APPENDIX F

ROCK QUALITY DETERMINATIONS, ROCK MULCH AND RIPRAP

FIELD MODIFICATIONS, SWALES A, B AND C

Minor Design Modification of Swale A

DATE: 5-30-91	FIGURE 5-1	DRAWING NUMBER 86-060-E544
SCALE: AS SHOWN

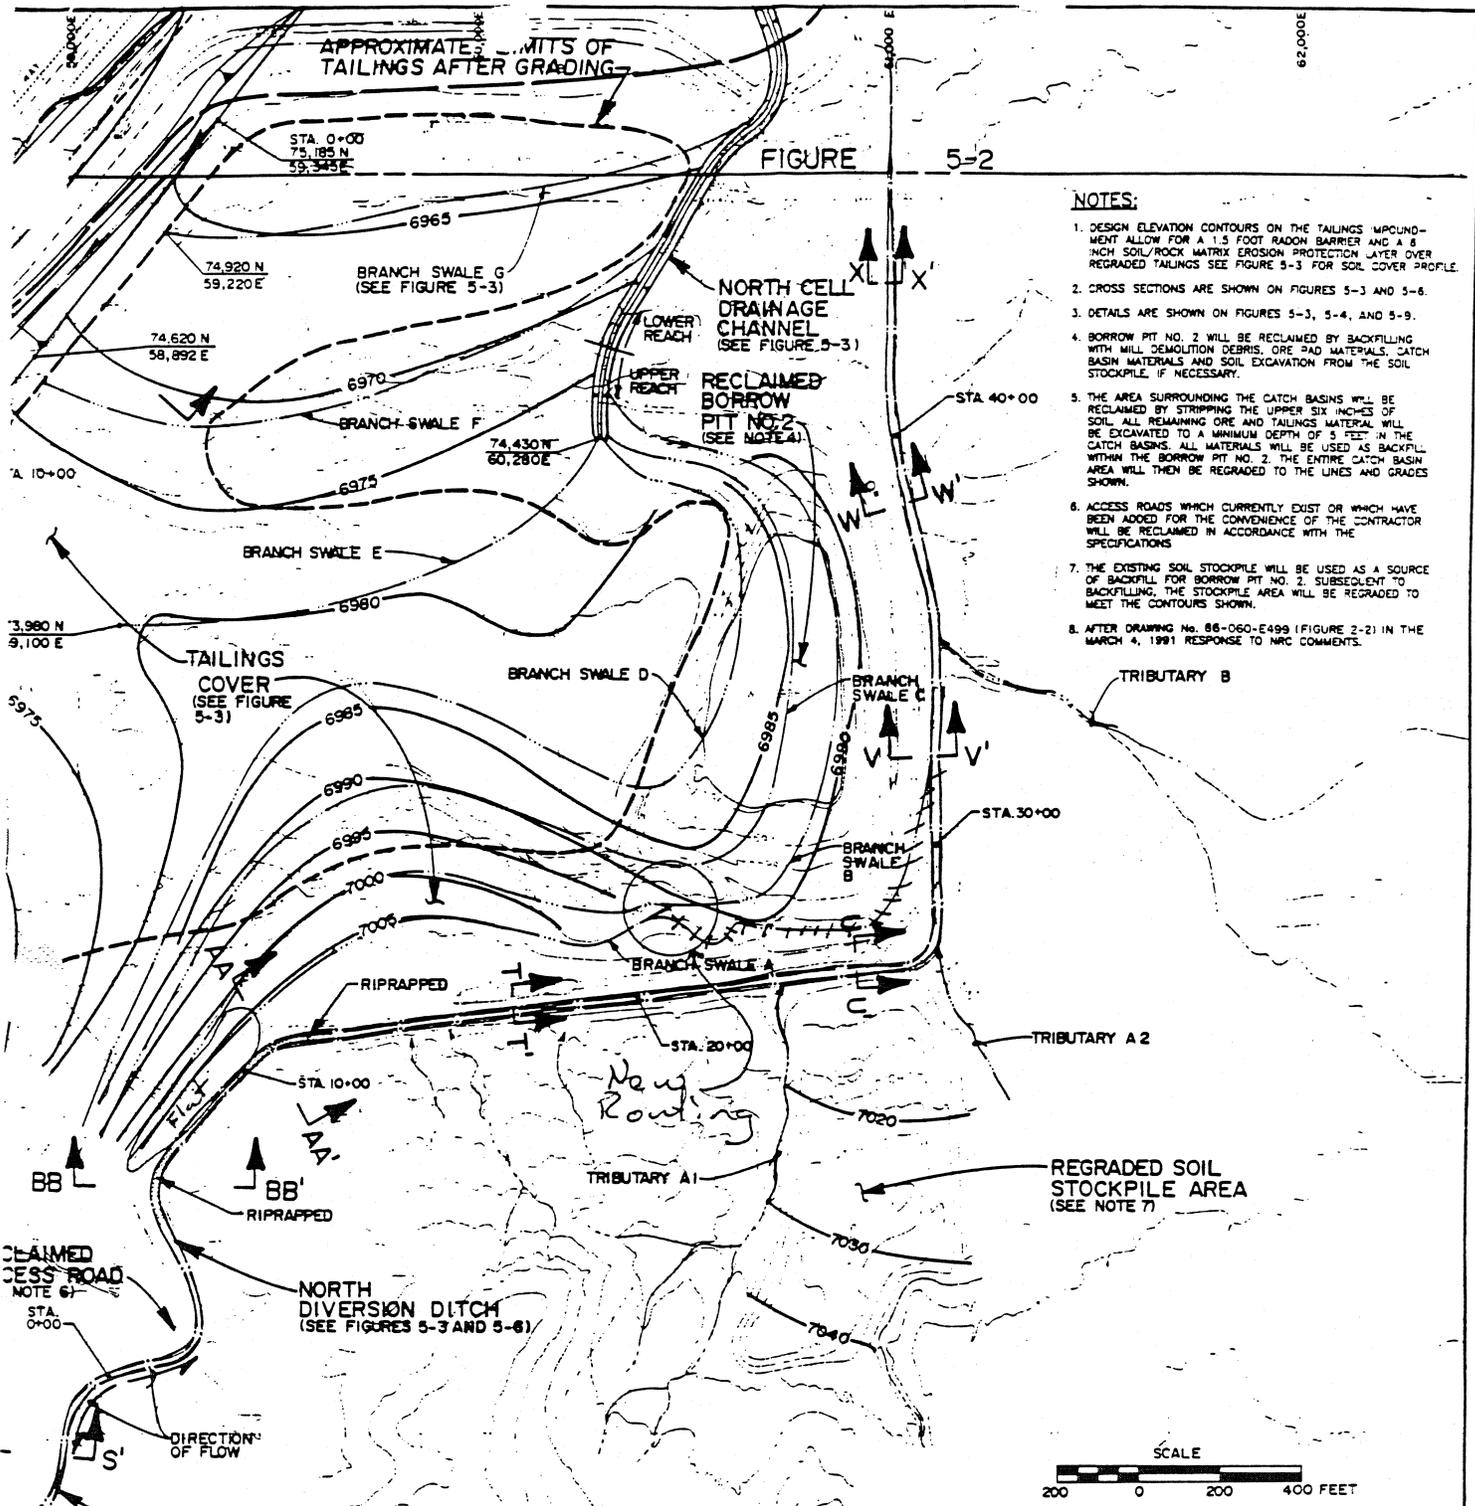
As we discussed earlier today, Swale A of the final cover design can be modified to discharge into Swale B rather than directly into the North Diversion Ditch. This modification can be made provided that the riprap in Swale B is increased to a D_{50} of three inches and a thickness of six inches in that portion which is downgradient of where Swale A discharges into Swale B. This minor modification in the configuration of Swale A eliminates the need for excavating through the embankment which surrounds Borrow Pit No. 2.

This calculation brief evaluates the effect of rerouting Swale A into Swale B on the ditch design of Swale A, Swale B, and the North Cell Drainage Channel. The modification alters the slope of Swale A and the total flow in Swale B and the North Cell Drainage Channel. The channel dimensions, depth of flow, and riprap must be reevaluated to verify that each channel remains within the original design parameters of the Tailings Reclamation Plan.

The route of Swale B will be unaltered, so the slope of Swale B is not a variable. Given the original slope the required riprap D50 is calculated for the increased flow created by adding the flow of Swale A. The results show that below the confluence of the two swales the originally designated D50 of 1.5" will not be sufficient. The safety factor for the riprap dropped below 1.0 to 0.9. When the next larger riprap grading which has a D50 of 3.0" is substituted the safety factor is increased to 1.37 indicating that it will be sufficient. Therefore, The size of riprap used in Swale B will have to be increased from D50 = 1.5" to D50 = 3.0" below the confluence of Swales A and B.

FIELD DESIGN MODIFICATION SWALES H, I & J

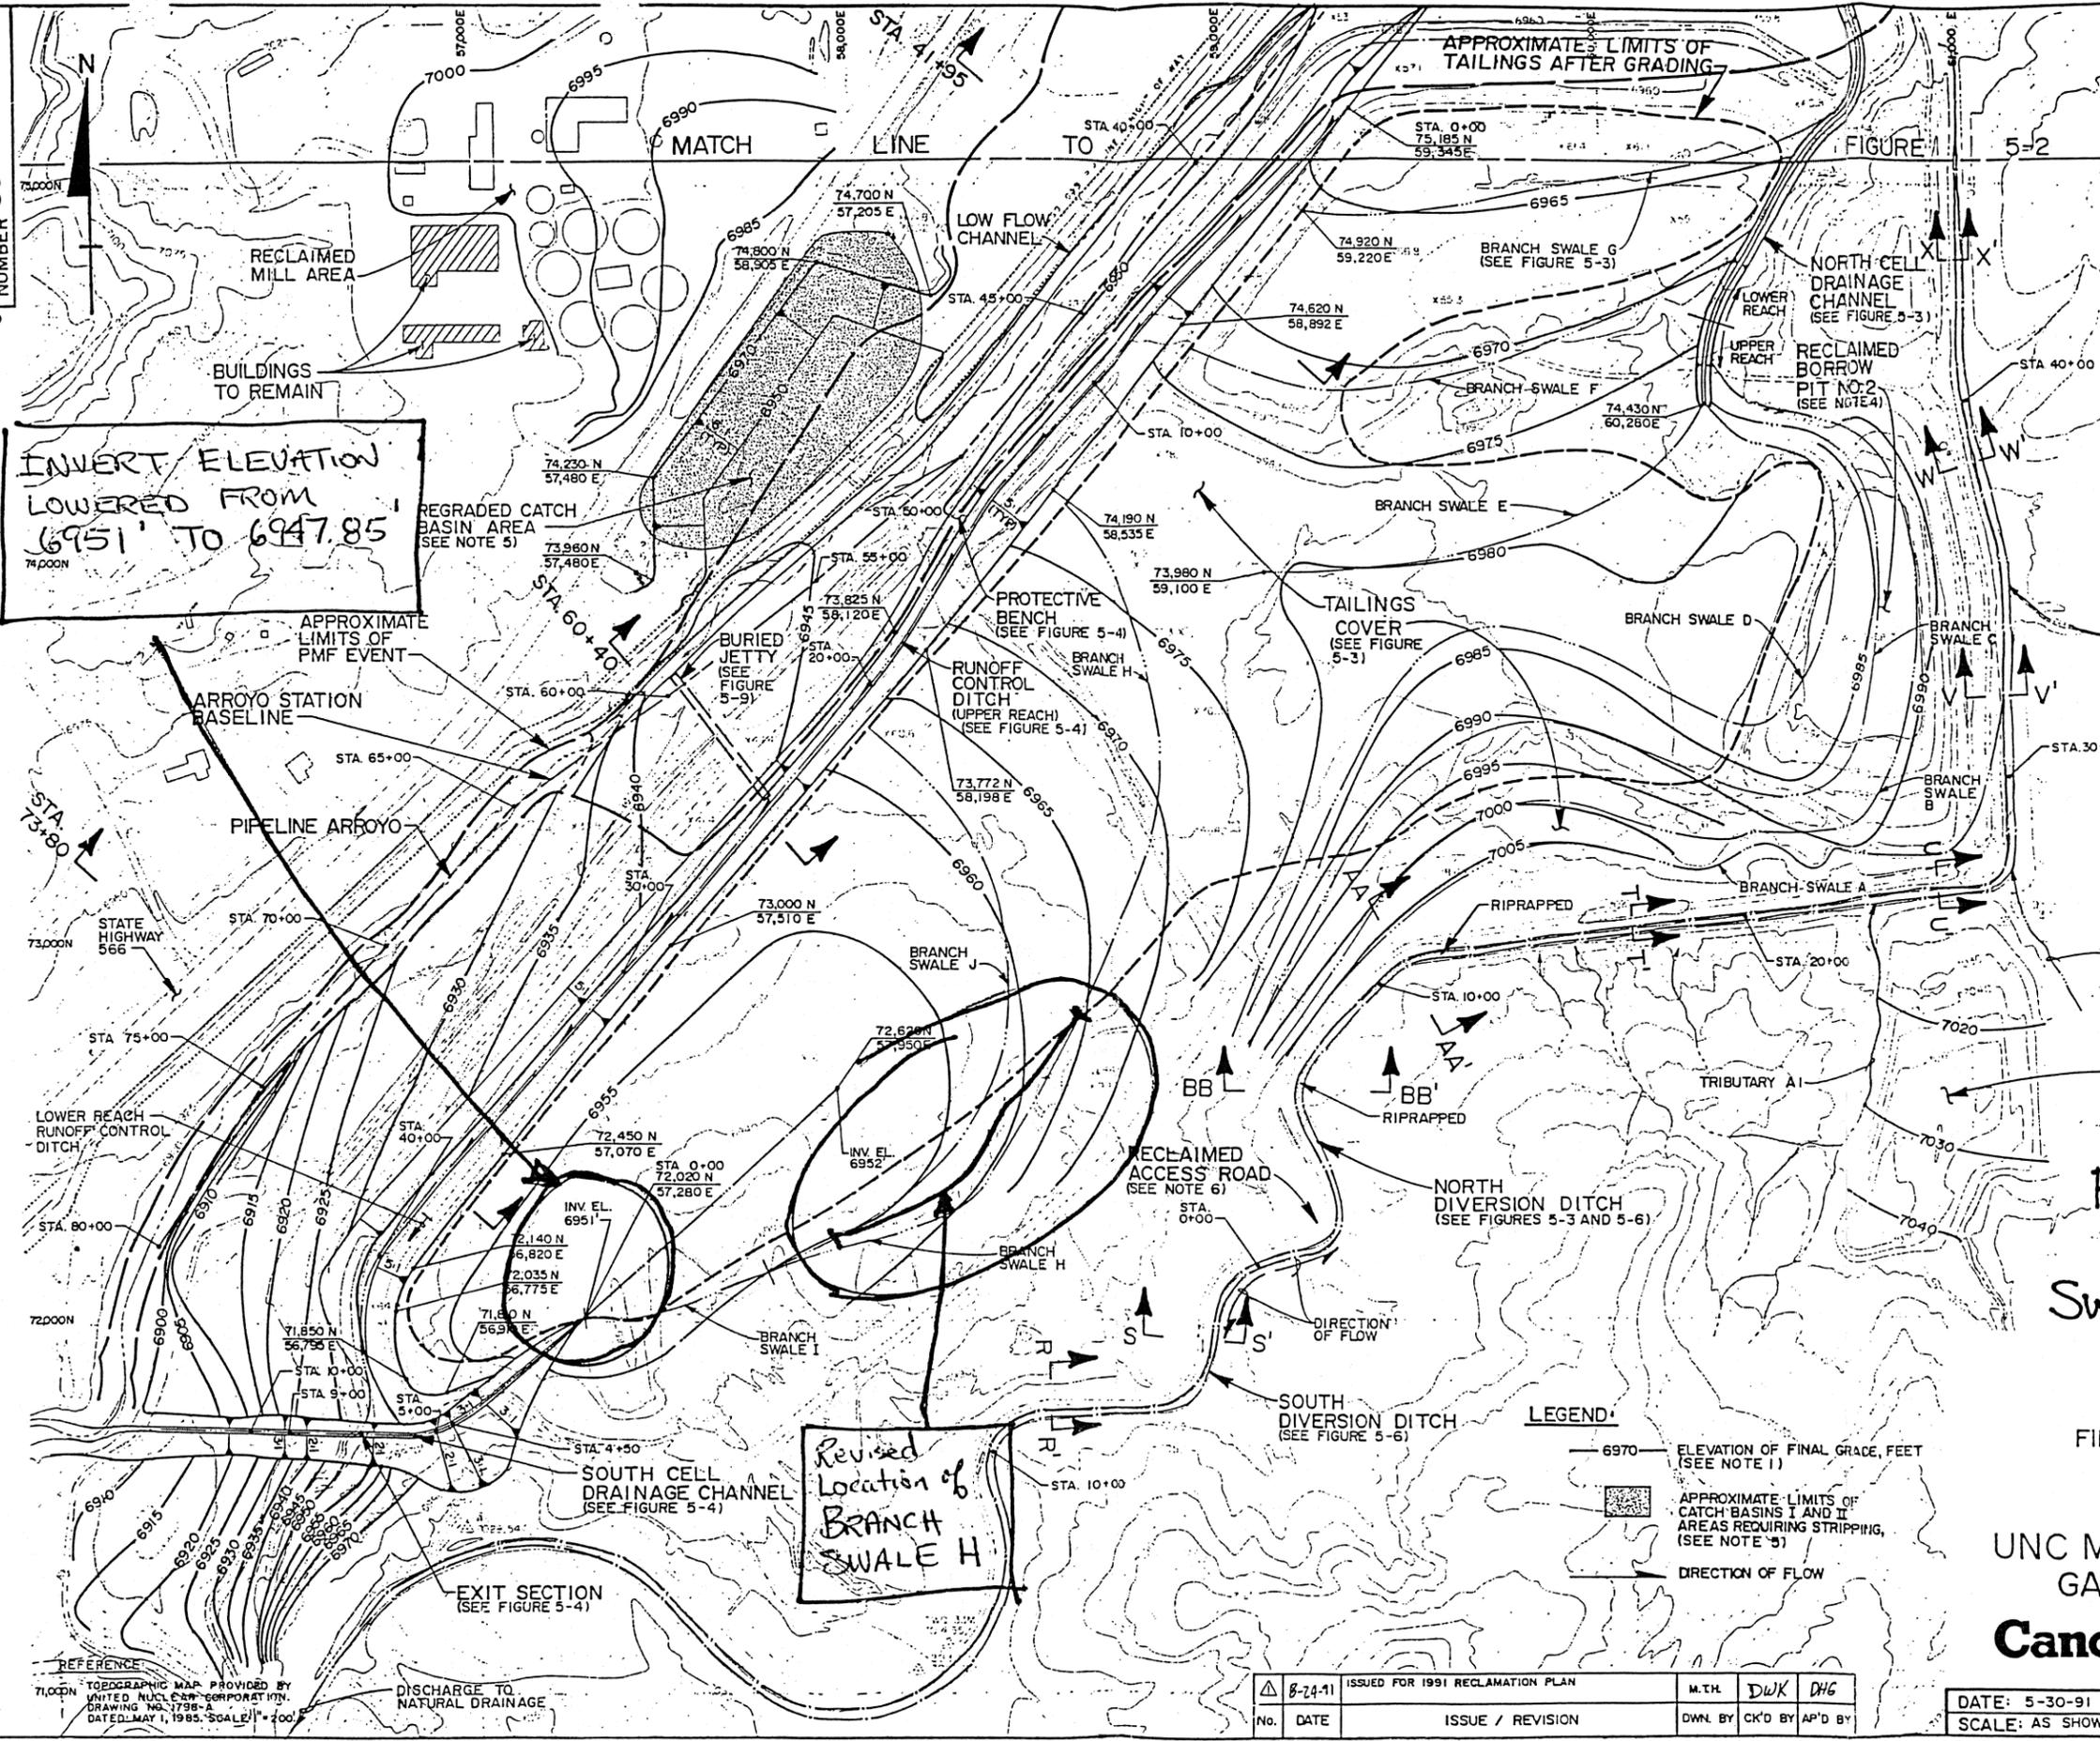
The lower portion of Branch Swale H was originally designed to pass through the bedrock outcrop area southeast of the South Cell of the tailings area. However, this design requires substantial excavation in the bedrock to construct the swale to the design grade. United Nuclear has proposed moving Swale H closer to the tailings areas as shown on the enclosed modified Figure 5-1. The invert elevation where Swale I flows into the South Cell Drainage Channel will also require modification from an elevation of 6951 feet to approximately 6947.85 feet (assuming a 3.5-foot deep swale) to match Swale I to the South Cell as-built contours.

These two field modifications result in moving the juncture between Swales J and H approximately 200 feet further to the northeast and increasing the grades of Swale I from 0.0040 to 0.0067 and Swale H from 0.0085 to 0.010. The grade of Swale J will remain the same at 0.0047. These modifications will not require any change in specified swale depths, bedding material or riprap because the calculated safety factors remain above 1.0. A copy of the supporting calculations for the changes in configuration of Swales H, I and J is enclosed.

Revised Location of BRANCH SWALE H

FIGURE 1

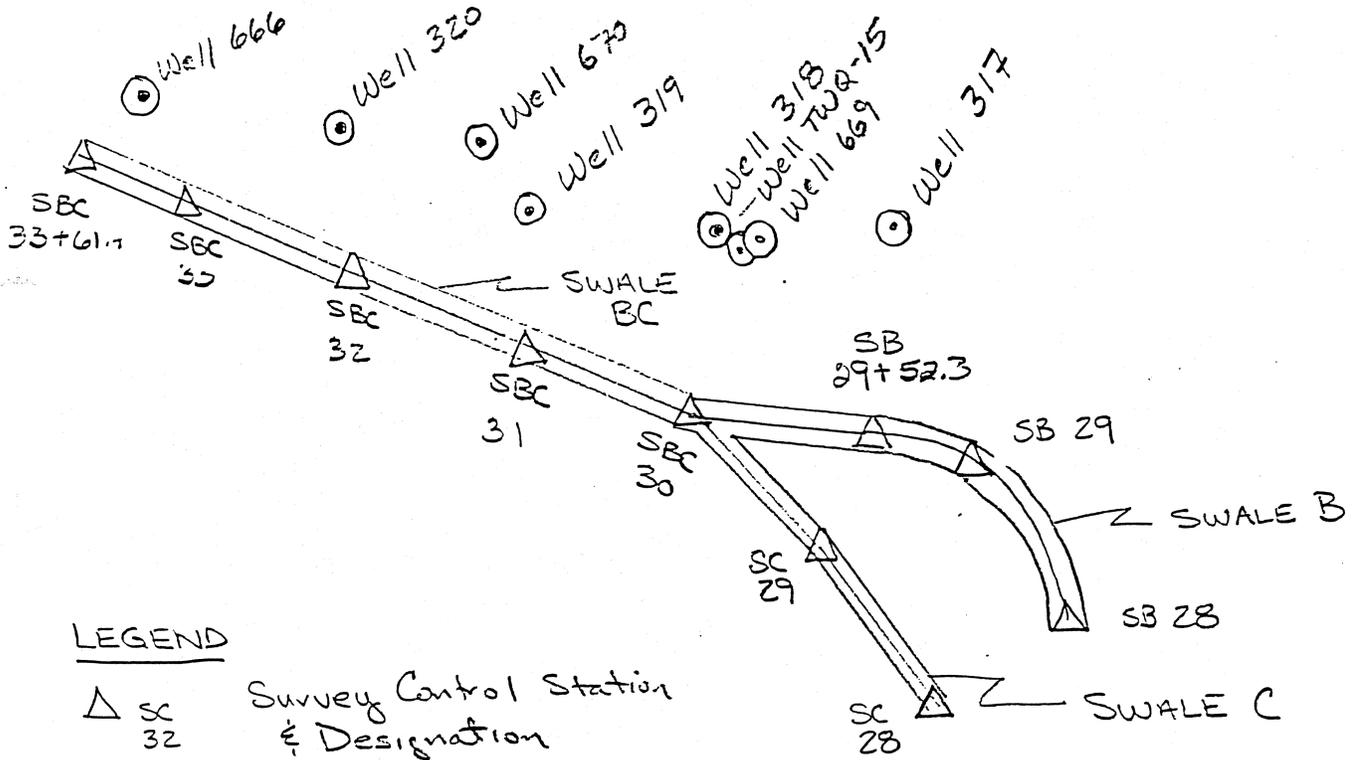
The reclamation plan calls for the placement of Bedding Layer 2 in a number of channels and swales, including Branch Swales H and I, which are to be completed this year. The bedding gradation specification listed in Table 5.7 of the reclamation plan calls for 5 to 12 percent passing the No. 40 screen size. However, the bedding material produced by the quarry is typically running about 14 percent passing the No. 40 screen.

Review of the original gradation calculations presented in United Nuclear's March 1991 response to NRC comments shows that Bedding Layer 2 (also called Filter Layer No. 2) can have up to 20 percent passing the No. 40 screen size in Swales H and I and the Lower Reach of the Runoff Control Ditch. Therefore, use of the finer gradation is acceptable for these areas, but would be unacceptable for the South and North Cell Drainage Channels and the North Diversion Ditch. Figure 1 of the original gradation calculations is enclosed for reference purposes.
